LEARNING RESOURCES CENTER
BUILDING 'D' AND 'CR' REMODEL

VENTURA COLLEGE

September 24, 2001
KBZ Job No. 93-18

INSPECTOR COPY

SHEET TITLE
MECHANICAL PLAN
BUILDING 'CR'

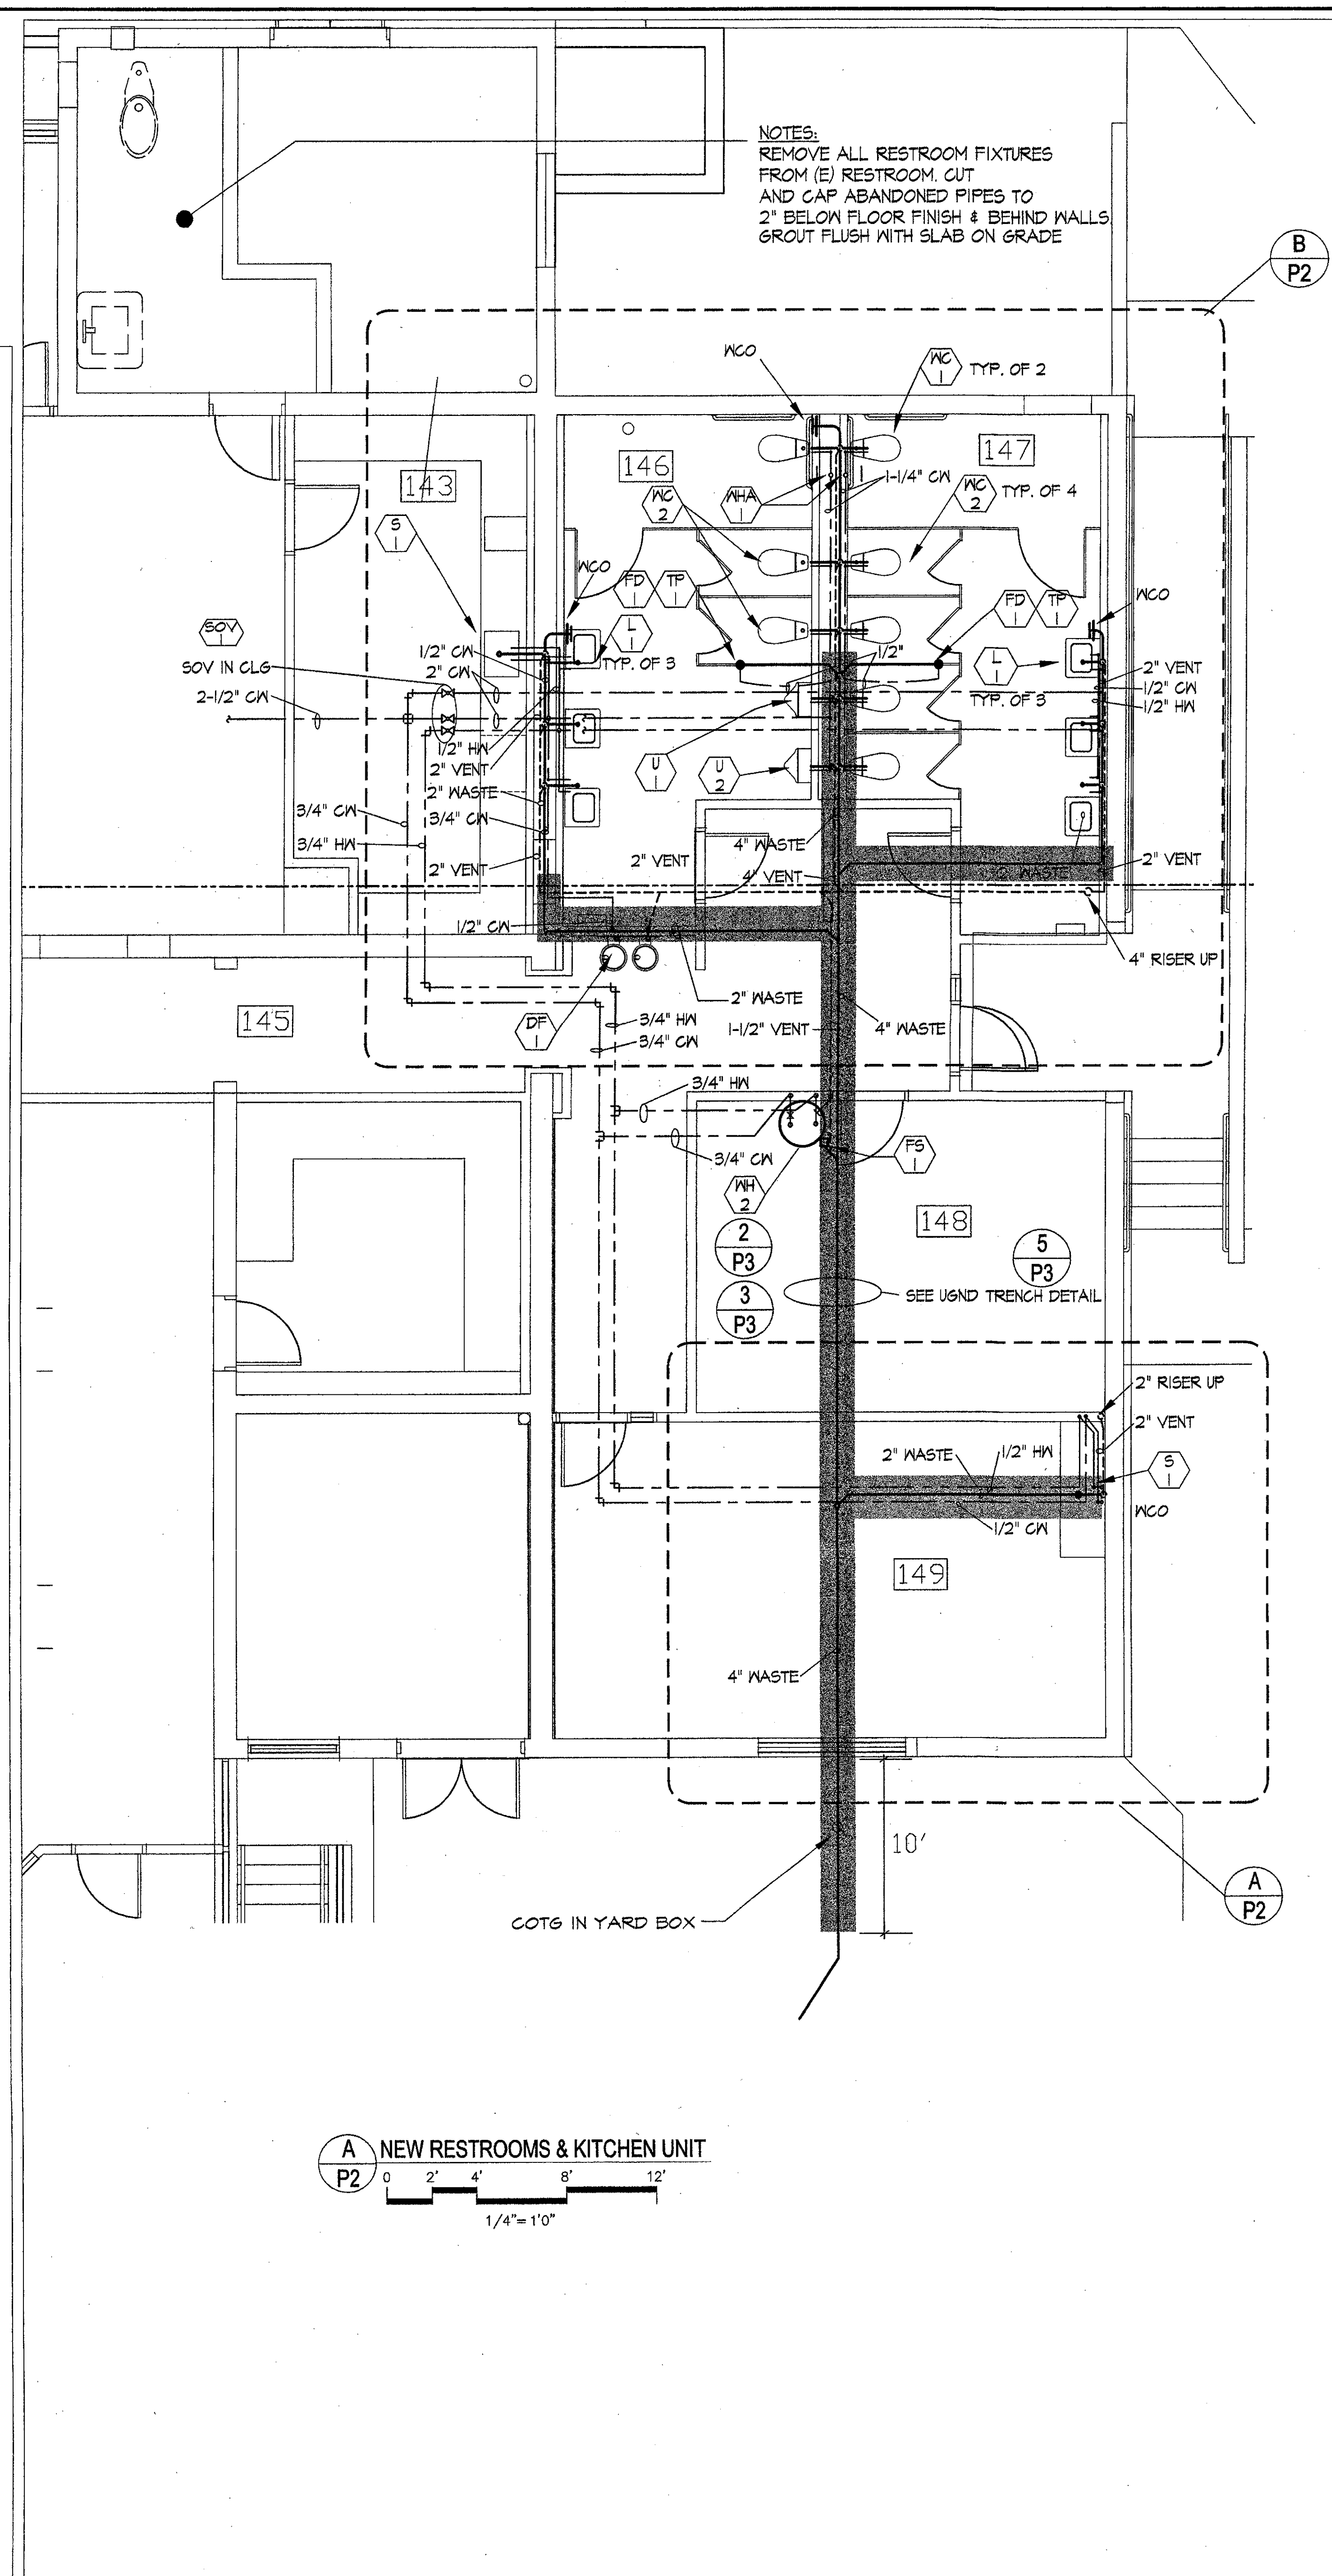
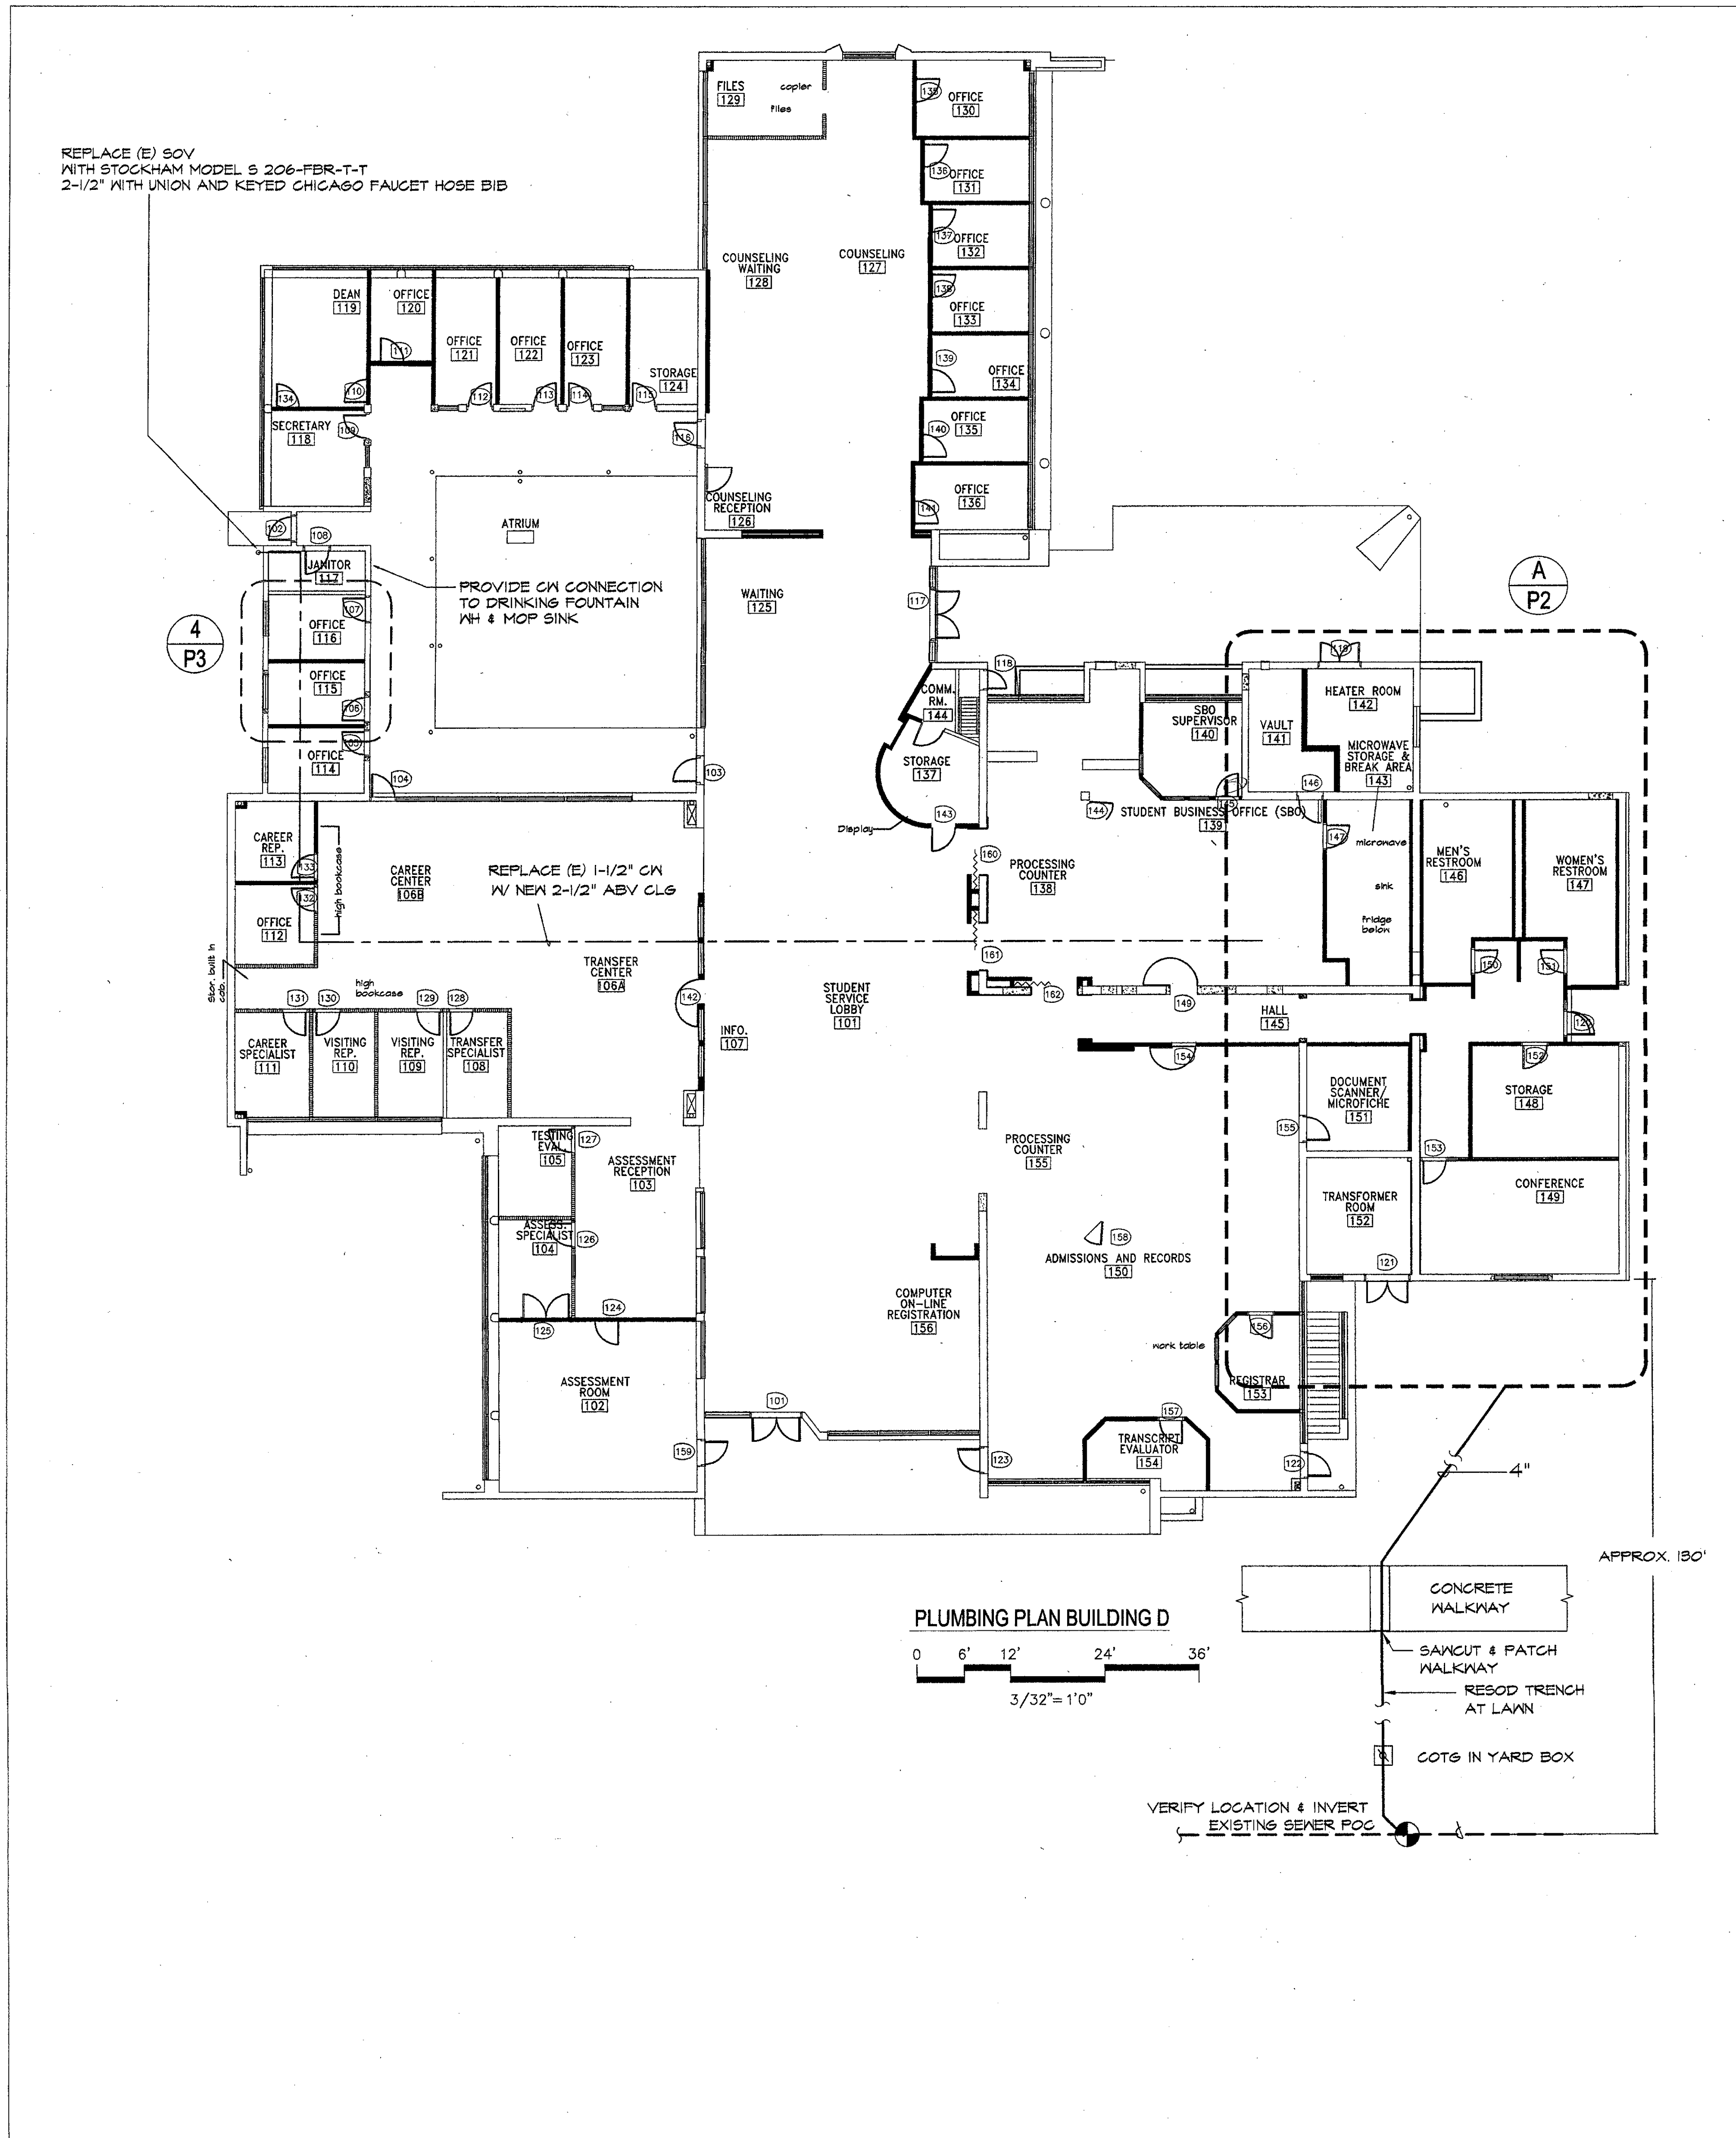
Item No. 24: Drawing Sheet M4 Addendum 6
Steel angles at AC-2 shall be hot dipped galvanized.

Item No. 25: Drawing Sheet M4
Wall flashing at duct penetrations shall per revision drawing MR-5.

Item No. 27: Drawing Sheet M2 & M4
Add the following note to drawing sheets:
"Contractor to provide and locate access doors as required for volume dampers at hard lid ceilings."

DRAWN
 CHECKED
 DATE SEPT. 24, 2001
 JOB NO. 9318B
 SHEET TITLE
 WASTE, VENT & WATER PLUMBING PLAN & DETAILS BUILDING 'CR'
 SHEET
 P4
 OF

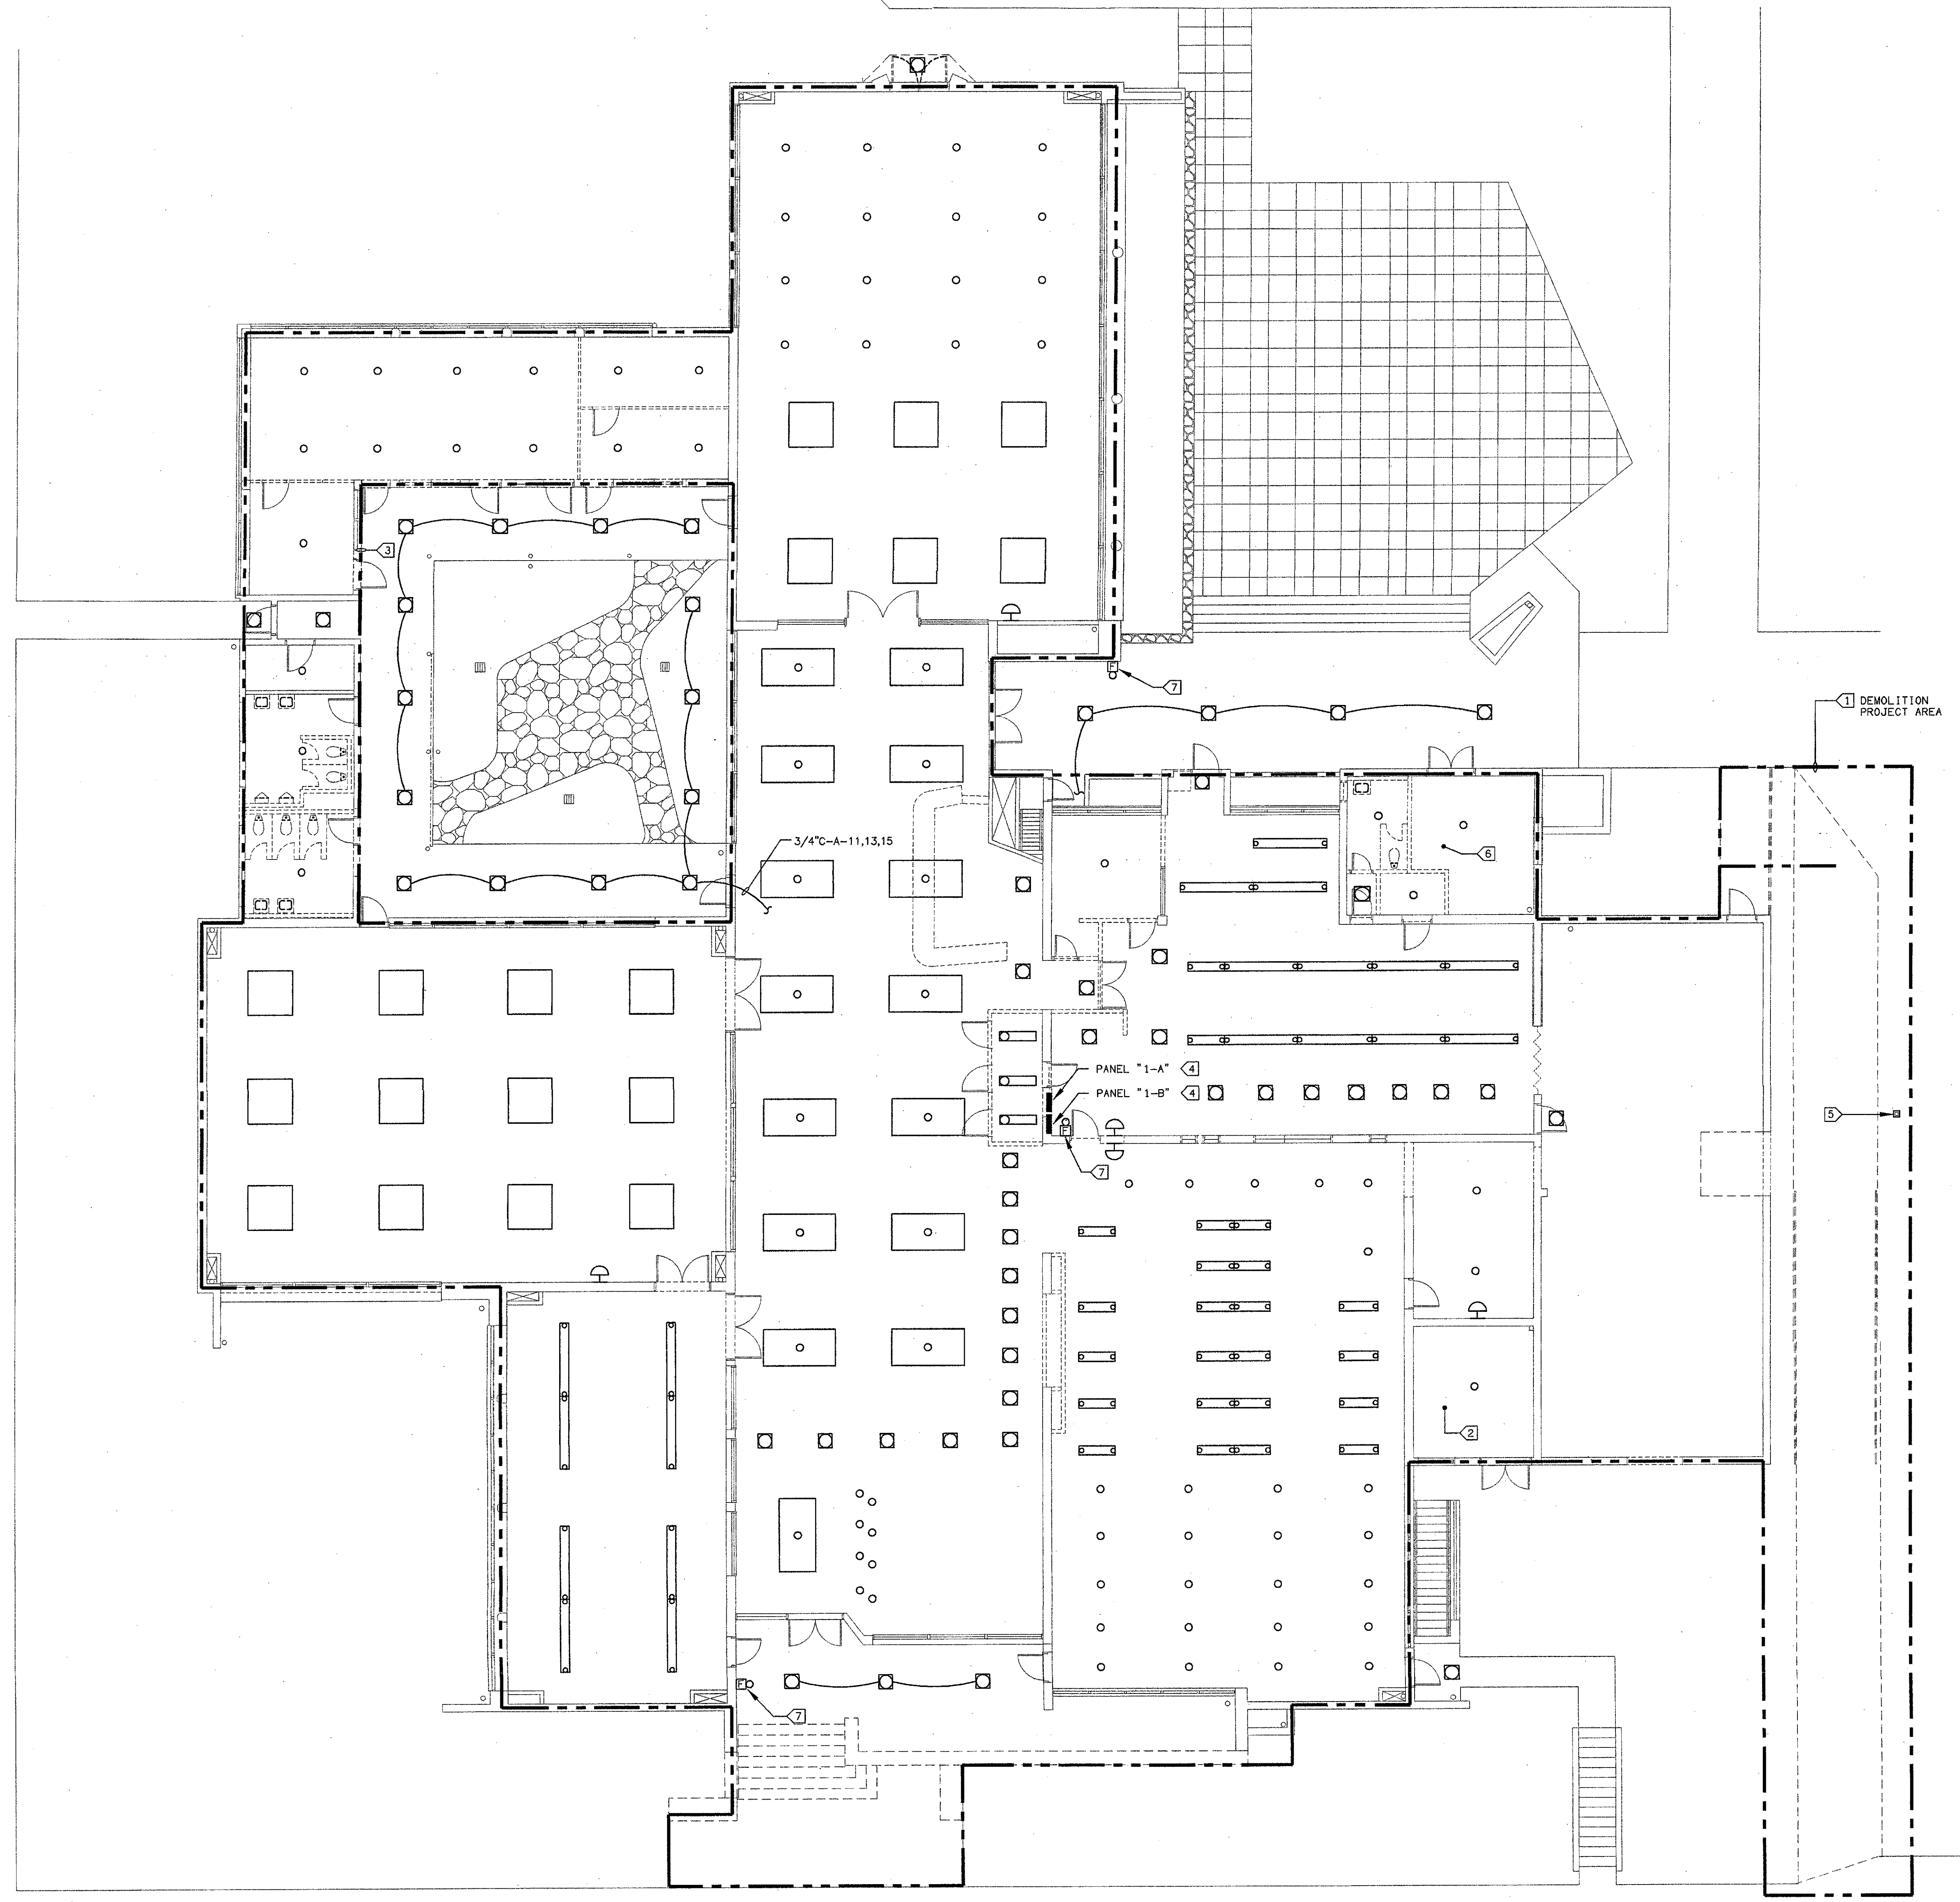
ITEM 37. Drawing Sheet P4. 0-00640/0/0-2
 Plumbing demolition at building 'CR' shall be as described on Architectural Sheet A-102 for fixtures to be removed. Cap or plug below grade or behind wall finish any related piping.
